SFMTA - TASC SUMMARY SHEET

Location: Vermont Street, North of 23rd Street

Subject: Red Zone

Re: Visibility Analysis for UCSF ZSFG Roadway and Site Improvements Project

**STRIPING &
SIGNAGE PLAN**

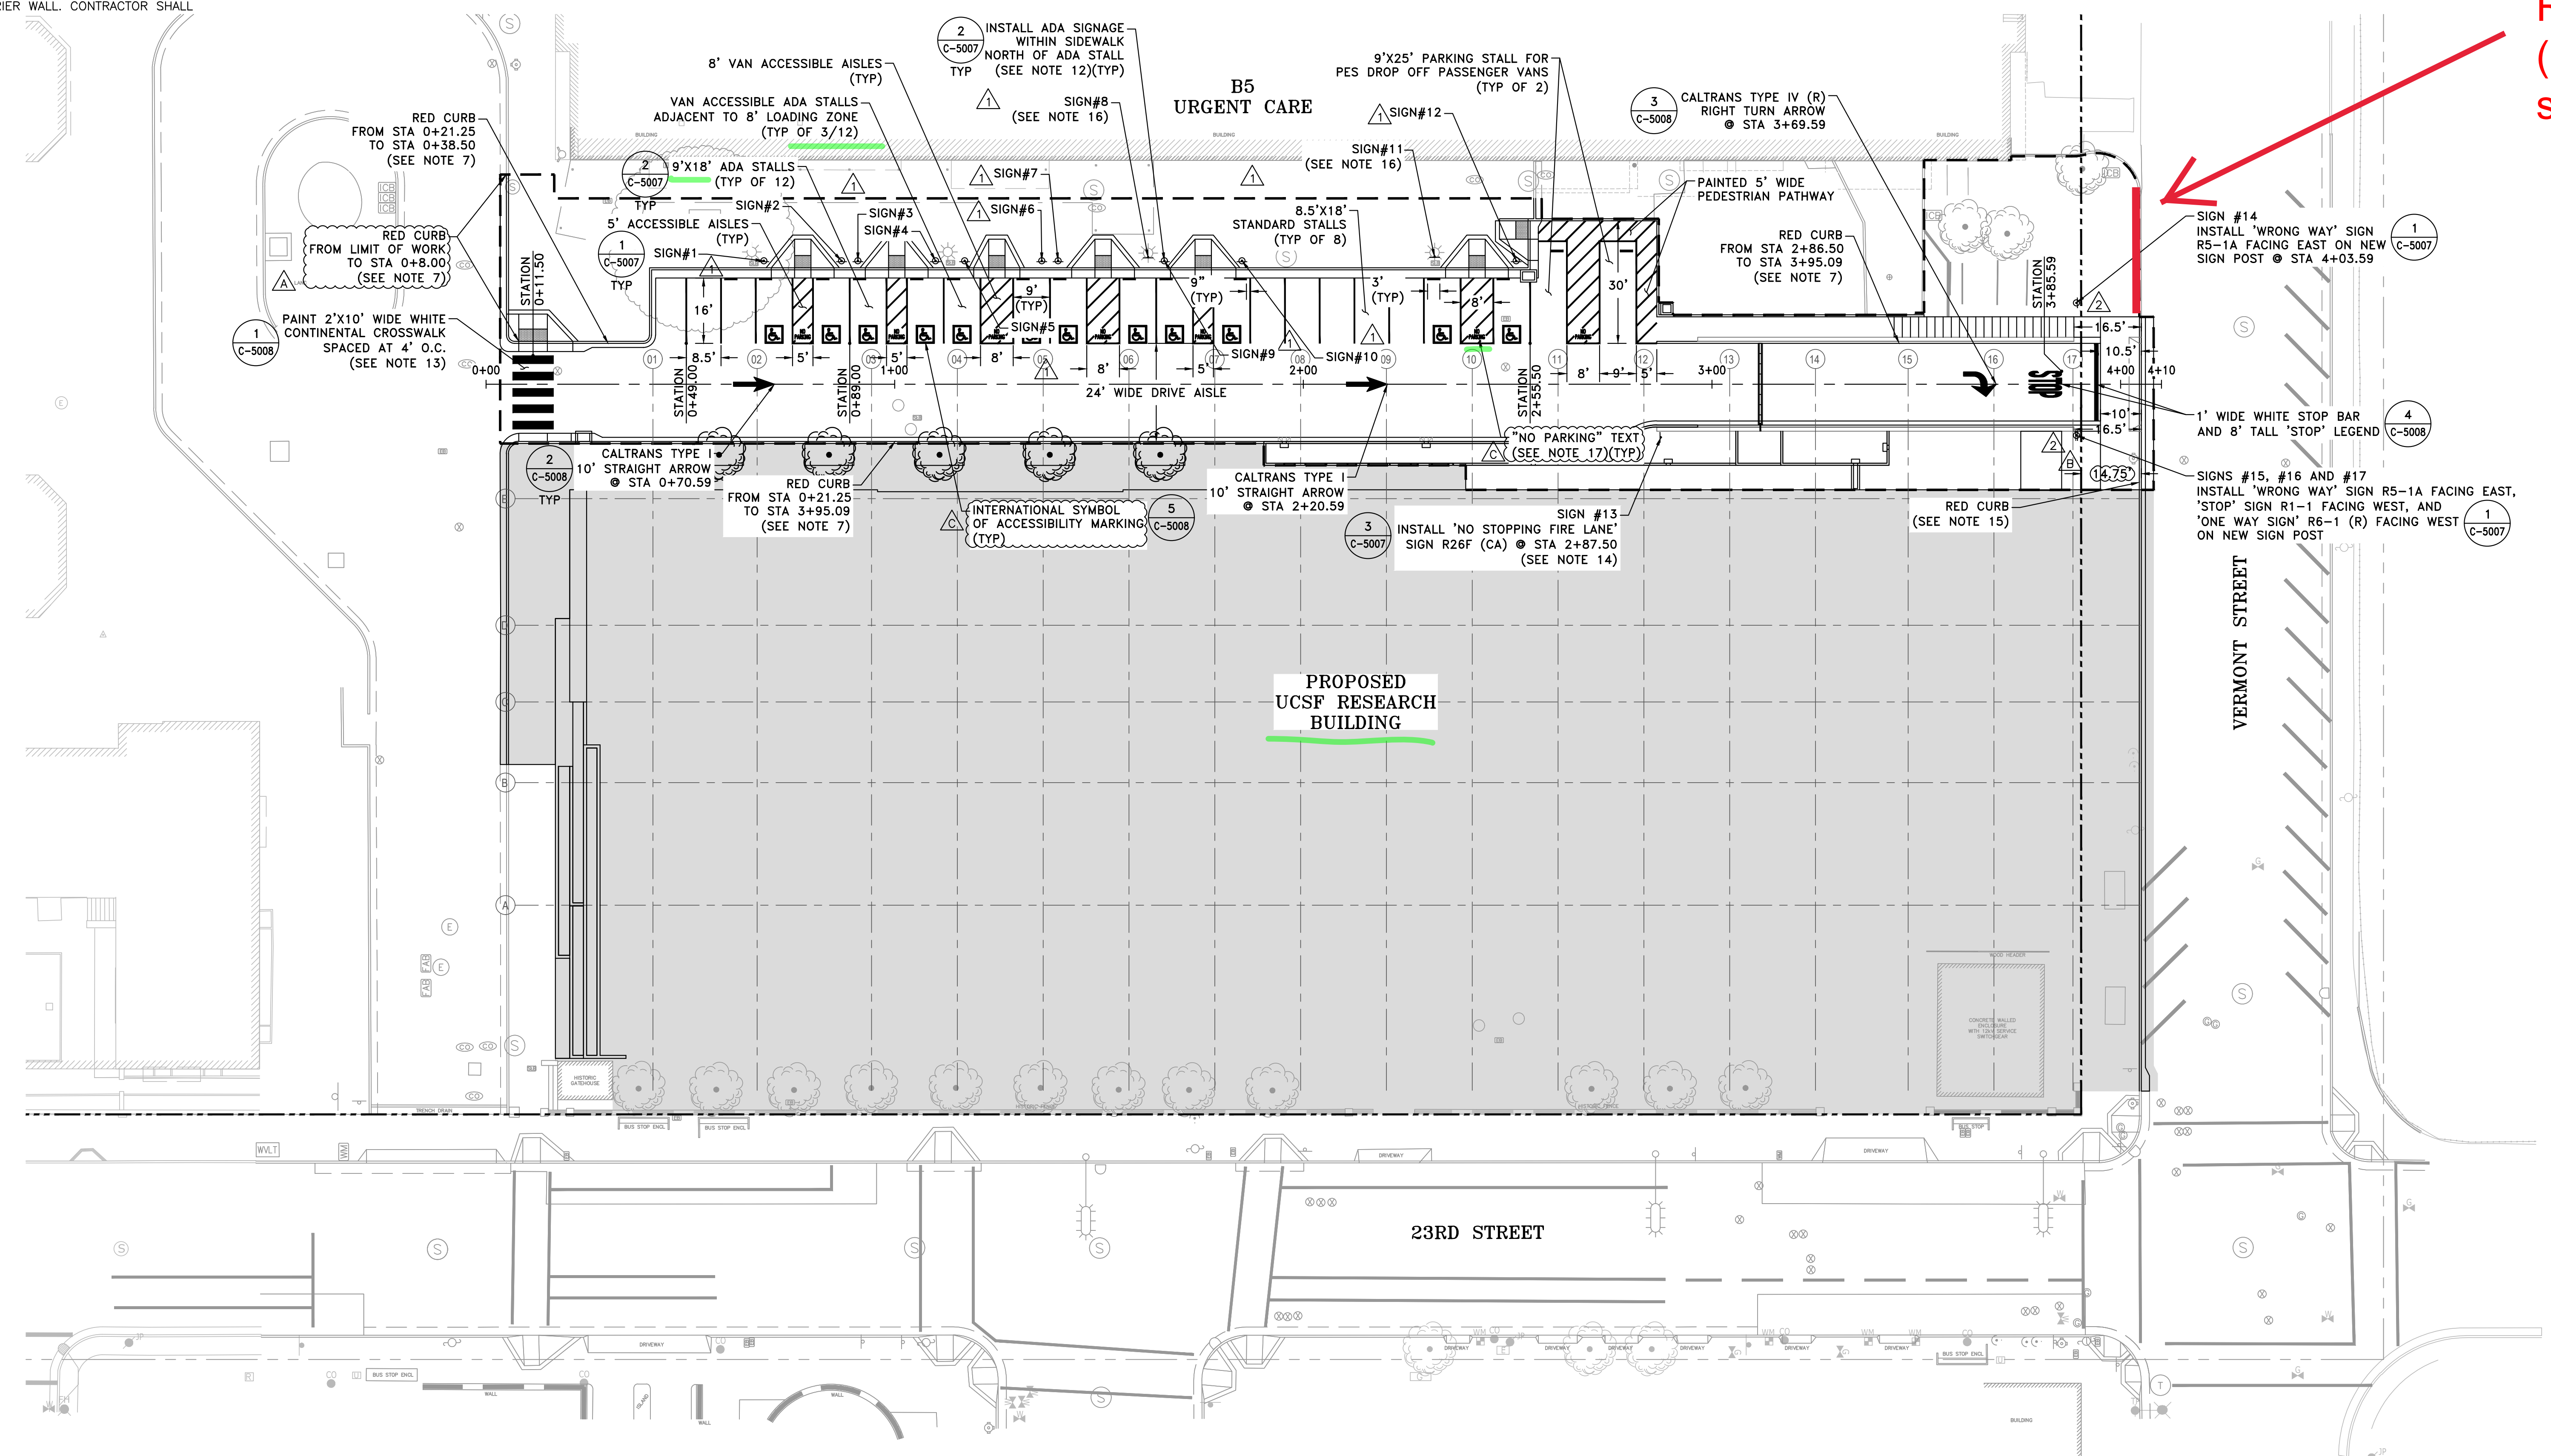
Red Curb (removes 2 spaces)

ESTABLISH RED ZONE
Vermont Street, west side, from 195 to 225 feet north of 23rd Street
(Supervisor District 10)

Removal of two Zuckerberg General Hospital staff parking spaces, adjacent to the new driveway for Building 7, is required to provide adequate sight visibility for outbound driveway vehicles exiting onto Vermont Street.

Appendix 1: Sight Distance Analysis Exhibit

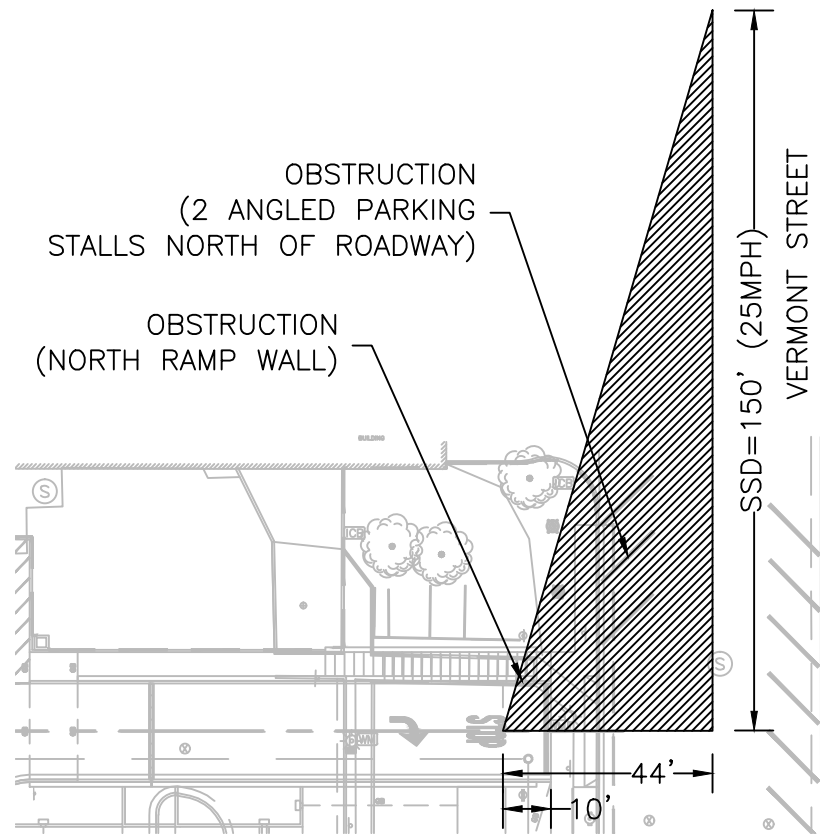
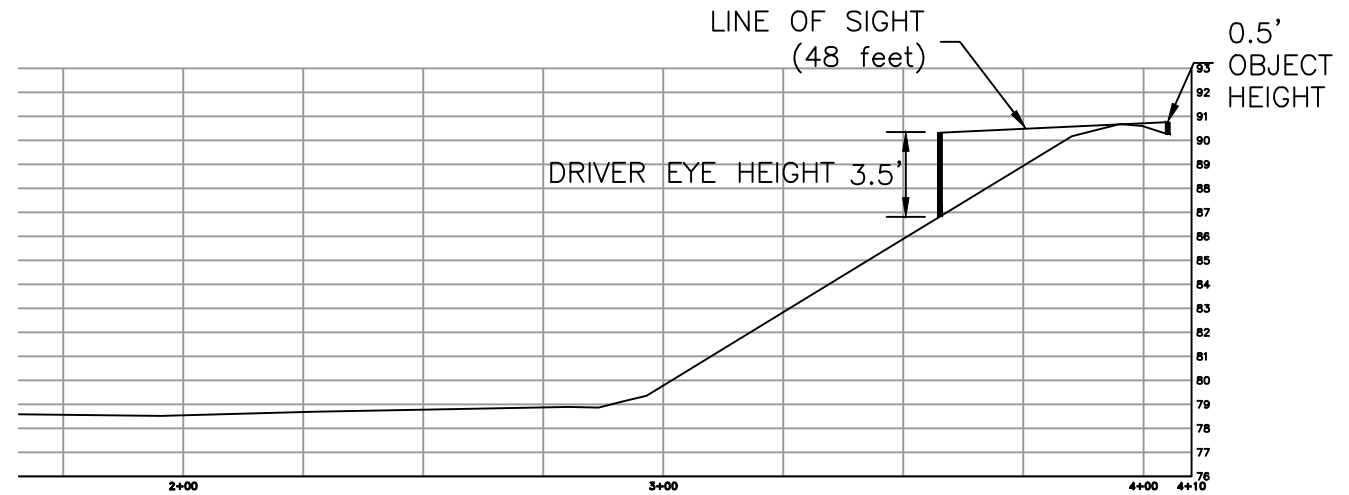
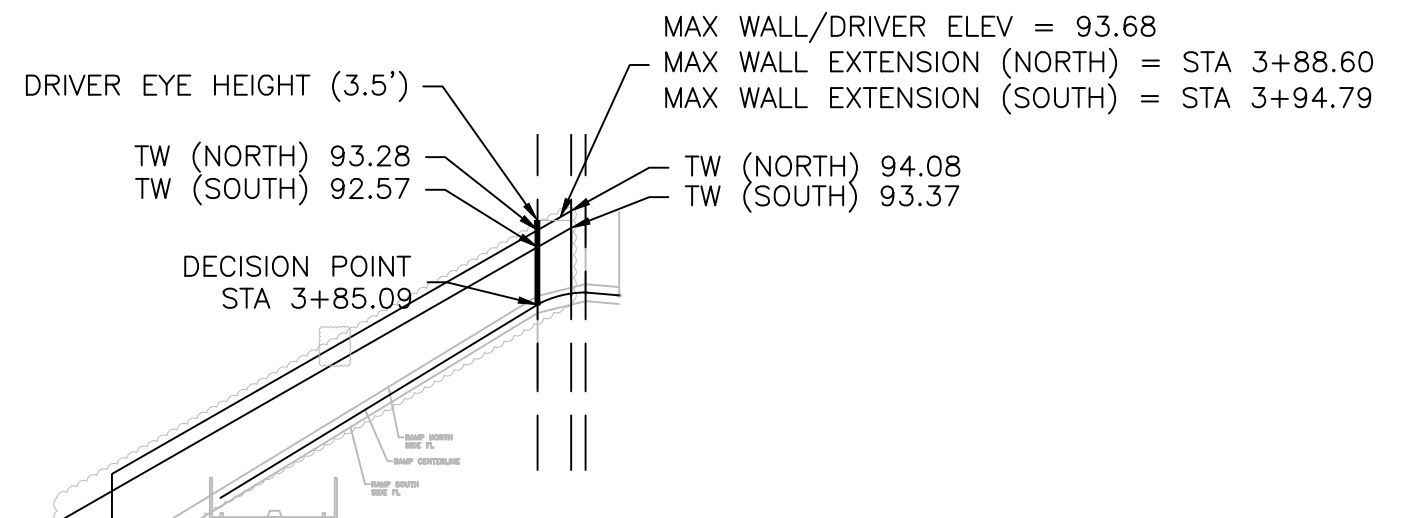
The minimum recommended horizontal stopping sight distance is 150 feet for a vehicle travelling at 25 mph. **Appendix 1** (left figure) shows the sight distance triangle drawn from driver's decision point in the plan view. The sight distance triangle shows that there is an obstruction limiting the sight distance due to two existing angled parking spaces, located immediately north of the new driveway. The parked vehicles will not only fall within the sight distance triangle and but also exceed the driver's eye height of 3.5 feet. It is recommended to eliminate two angled parking on the west side of Vermont Street, so sight distance will be improved.

Appendix 1 (bottom-right figure) shows the height and extension of the ramp wall on the north and south side of the roadway. The south ramp wall is compliant because existing design is already lower than driver's eye height at decision point. However, the design elevation of north wall at the east end is 94.08 feet, which is 0.5 foot higher than driver's eye height at decision point. As a result, the north wall will need to be restricted to no more than 93.68 feet in elevation. Alternatively, the east end of the wall will need to be shortened horizontally to the west by at least 3.5 feet from existing design to Station 3+88.60.

The measured sight distance at the new driveway is 48 feet as shown on **Appendix 1** (top-right figure). The profile view shows the line of sight drawn along the new driveway from the object 0.5-foot-high on the sidewalk to the driver located 48 feet away whose eye height is 3.5 feet. The minimum recommended stopping sight distance is 50 feet for a vehicle travelling at 10 mph. Therefore, sight distance for this section of driveway is not adequate.

1. Two existing angled parking spaces, located immediately north of the new roadway, will need to be removed because the parked vehicles will not only fall within the sight distance triangle and but also exceed the driver's eye height of 3.5 feet.
2. The height and extension of the south ramp wall is compliant, but the north wall will need to be restricted to one of the following:
 - a. The maximum height should be no more than driver's eye height at decision point.
 - b. The east end of the wall should be shortened horizontally to the west by at least 3.5 feet from existing design.
3. Based on 48 feet of sight distance along the new driveway, it is recommended to install speed limit (R2-1) sign to limit the vehicle speed at 5 mph.

SHEET NUMBER: ASK-064

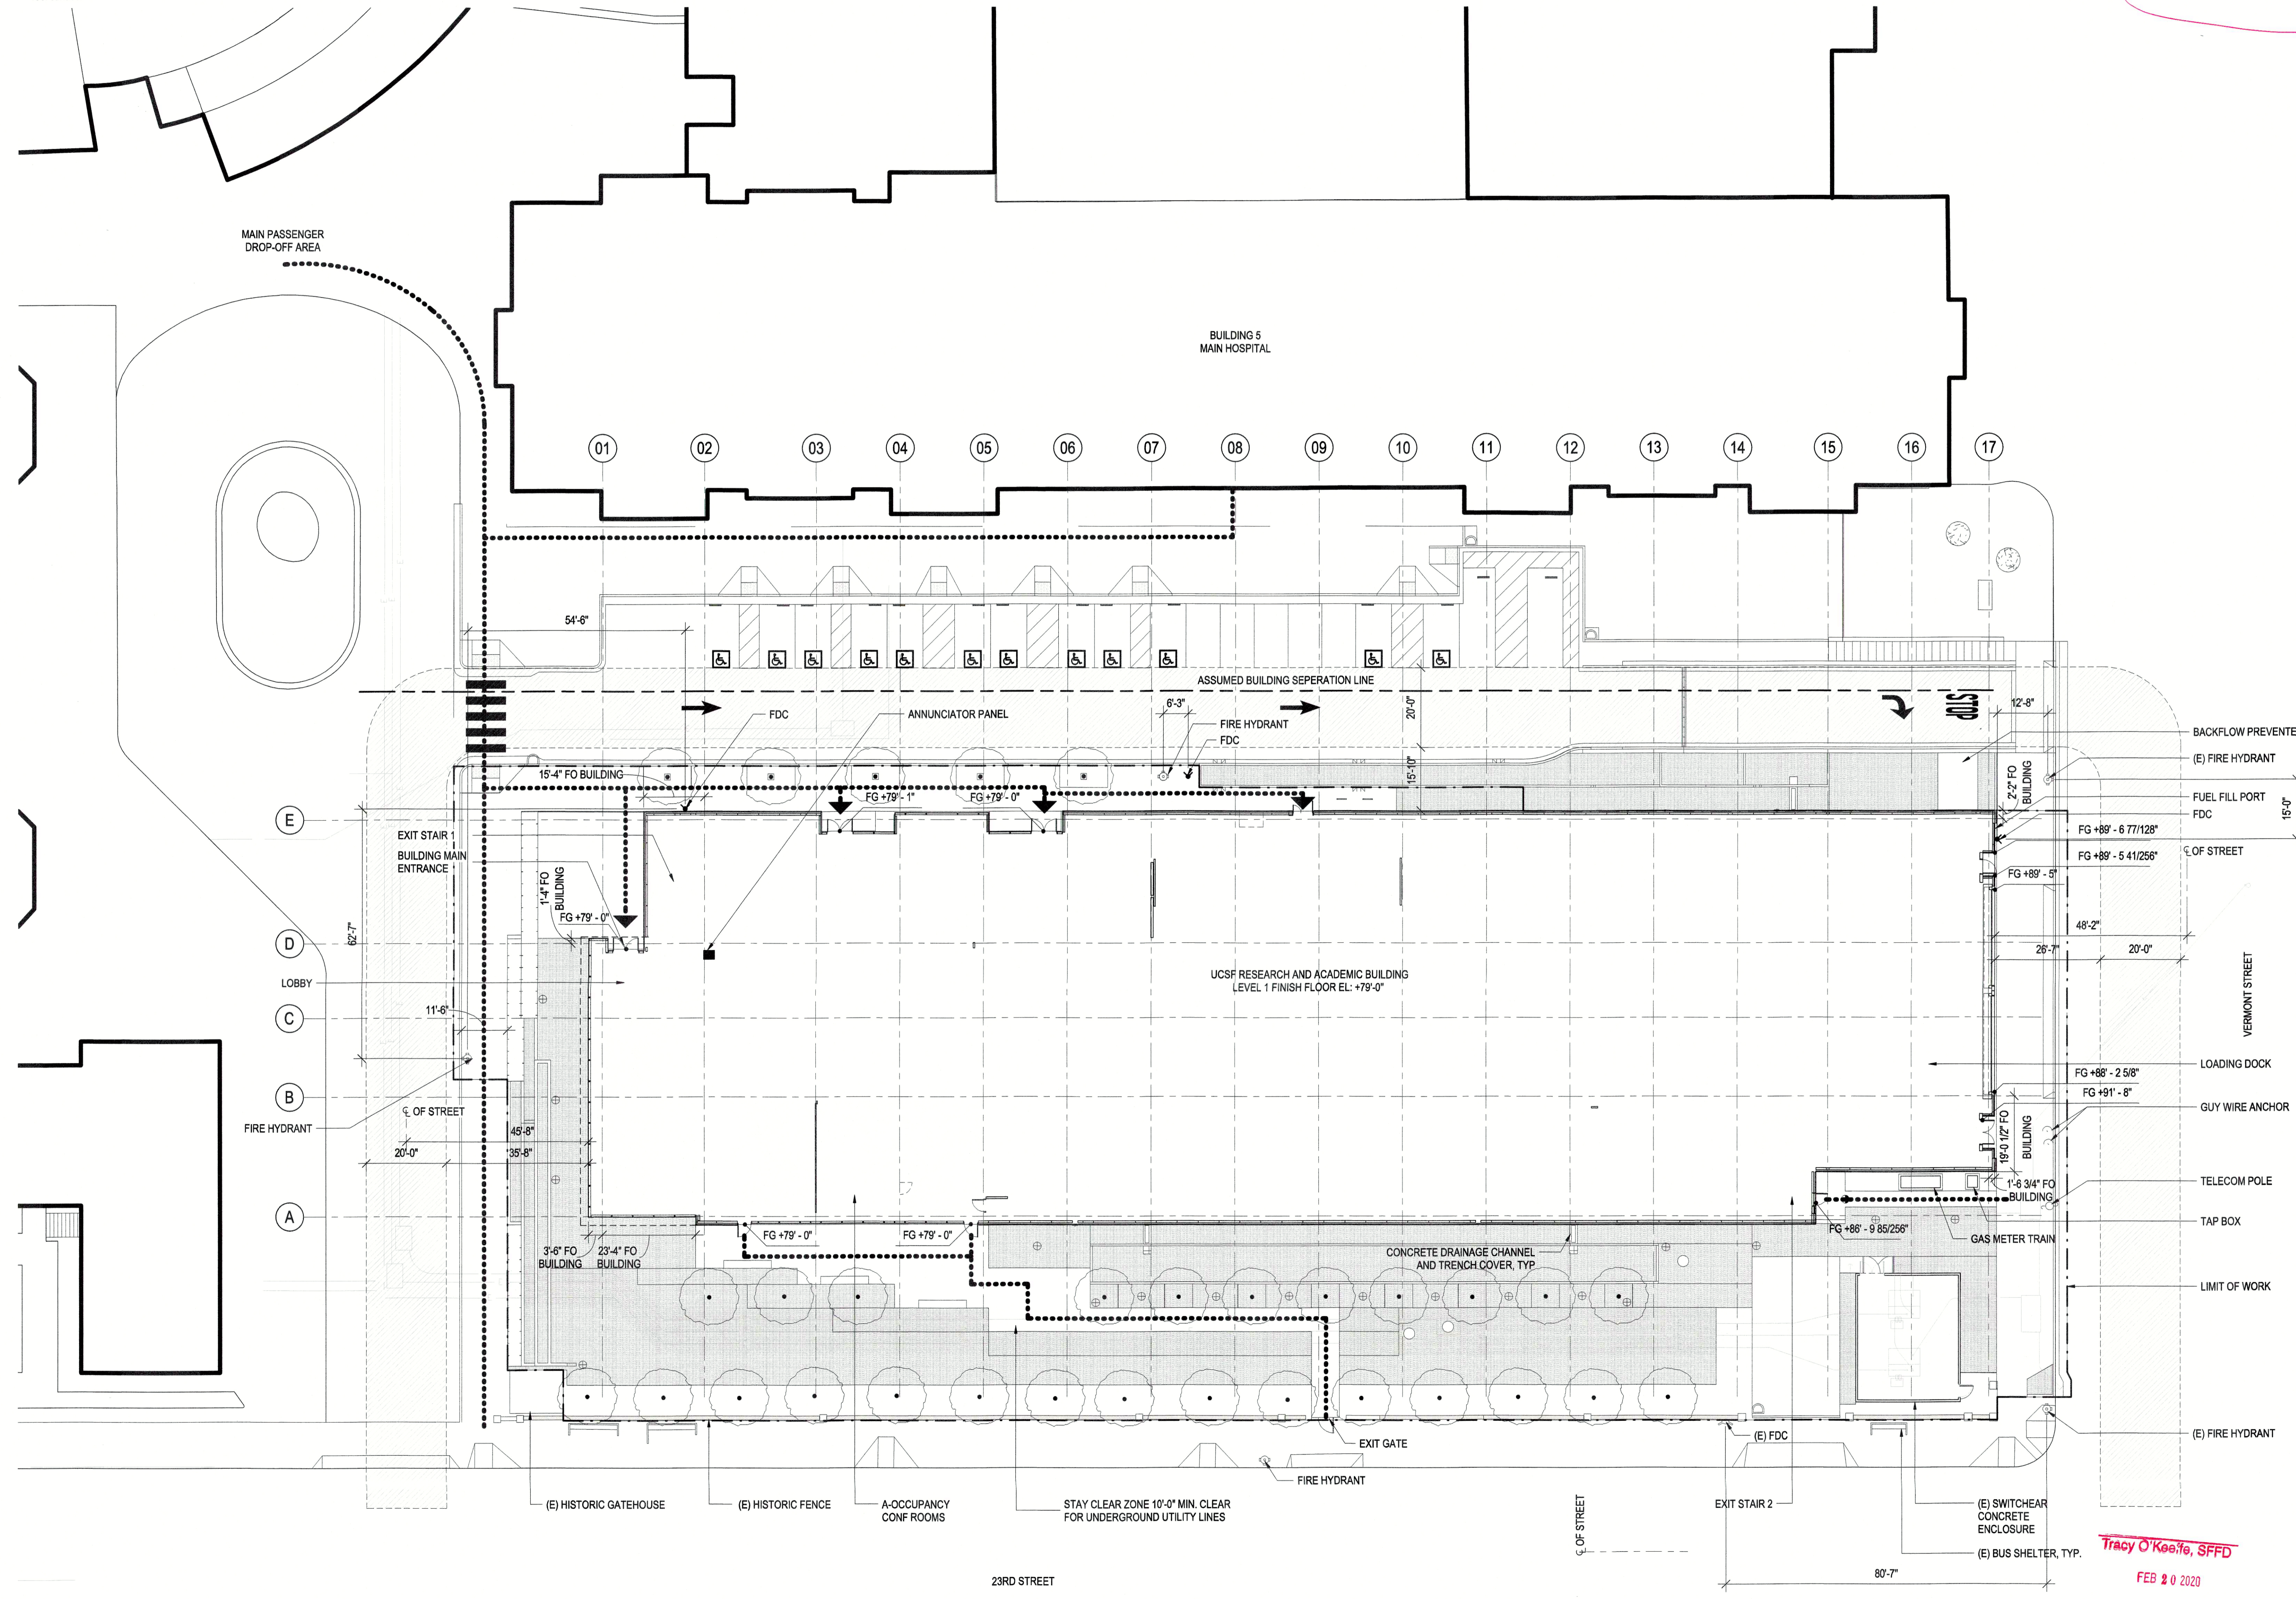
Ensure all FDC and SFFD connections are 3" inch inlets, and outlets
